APPENDIX C – CHS9038

Consultation Response Summary

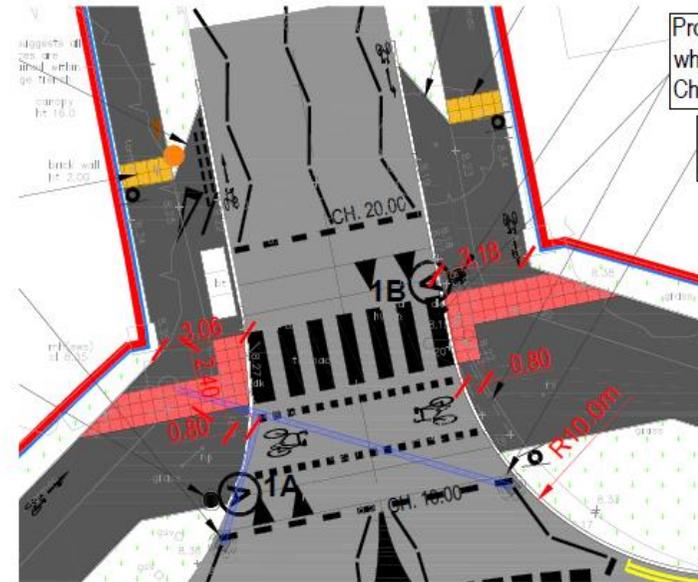
<b>Objection/Comments</b>	<b>Comments from Director of Highways &amp; Transport</b>
1	<p>Resident of Old Broyle Road</p> <p>Objects to the introduction of two parallel crossings at the Sherborne-Rd/Westgate mini roundabout. This will:</p> <ul style="list-style-type: none"> <li>• Lead to collisions between pedestrians and cyclists as the pavements are too narrow and the sight lines, often obstructed by brick walls, are inadequate</li> <li>• Lead to antagonism between pedestrians and cyclists at a time when we should be encouraging people out of their cars and onto their feet/bikes</li> <li>• Set a precedent for the remaining links between the West of Chichester Development and the City, particularly along the proposed route of the Southern Access Road</li> </ul> <p>At particular risk of injury are school children going to Bishop Luffa and people with restricted mobility.</p> <p>Moreover, plans that have recently been released towards the imminent construction of the West of Chichester Development Phase Two Southern Access Road, show that the spine road for this 1,600 new home development will directly connect at the location of the existing Sherborne Rd mini roundabout requiring virtually all cycle traffic to be transferred onto the existing pavements!</p> <p>This is completely unacceptable and the TRO should be rejected.</p> <p>What is needed are segregated paths for pedestrians and cyclists that meet official design standards.</p>	<p>The mini roundabout in its current format was seen as a barrier for less confident cyclists. Allowing the shared facility to provide off road facilities at a 4-arm junction for less experienced cyclists especially those children attending Bishop Luffa is seen as beneficial in encouraging more children to cycle and achieve a reduction in school drop off and pick traffic.</p> <p>The available shared use width is 3.06m on the (western side) and 3.18m on the eastern side. LTN 1/20 Table 6-3 of 3.0m which the design adheres to for up to 300 cycles per hour. However, the existence of walls on the bends leaves effective widths of 2.5m at these locations. CD 143 Table E/3.4 states that a minimum effective width of 3m for an unsegregated shared footway/cycleway. This can be reduced in accordance with clause E/3.5 which permits a minimum width of 2.0m where there are less than 200 users per hour. Whilst 3m or more would be ideal, and effective width of 2.5m still provides effective service, taking into account the constraints that exist. The available width in these locations ensures intervisibility between cyclists and pedestrians at the bends.</p> <p>See the General Arrangement Drawing Number WGSR-100 Rev P2 and clip below.</p>

Cyclists are expected to be moving slowly on the shared use footway/cycleways. Local Transport Note 1/20 states that shared use can be appropriate in certain situations and paragraph 6.5.6 lists one of these as being, "...At and around junctions where cyclists are generally moving at a slow speed, including in association with Toucan facilities...". This context is considered to be what is being proposed at the junction of Sherborne Road/Westgate but Parallel/Tiger crossings are proposed rather than Toucan crossings.

There are short lengths of shared facilities on the eastern approach to the mini roundabout (along Westgate) where cyclists transition from off to on-carriageway

<p>and vice versa. These lengths of shared facility are short (approx. 25m each) and it is expected that cyclists speeds will be very low on these two sections – cyclists will be making the transitions in order to use the parallels crossing.</p> <p>The majority of cyclists shall continue to cycle on the carriageway along Westgate and additional measures are proposed to assist with this. The shared pedestrian cycle route provides a safe means of access for those less confident cyclists and this route provides a safer means of negotiating the junction. Due consideration has been given through the design of the highway works to all road users including those that are more vulnerable to ensure that the scheme is appropriate for all; irrespective as to their level of mobility. A Stage 1 Road Safety Audit (RSA) has been undertaken at planning stage and further RSAs will be undertaken at each relevant stage (Stage 2 Detailed Design &amp; Stage 3 Scheme Completion) and acted upon as necessary. Appropriate signing, lining and tactile paving have been provided through detailed design consideration has been given to all reasonable safety measures.</p>

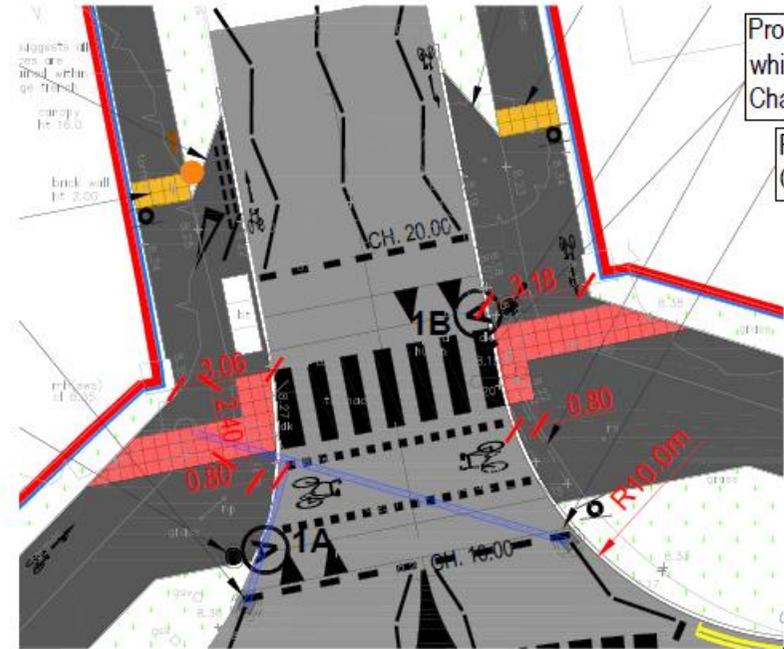
cyclists (taking advantage of the new pedestrian crossing points) then please can you support on road cycling by appropriate signage and road markings that allow the moderate cyclist to stay safely on the road.
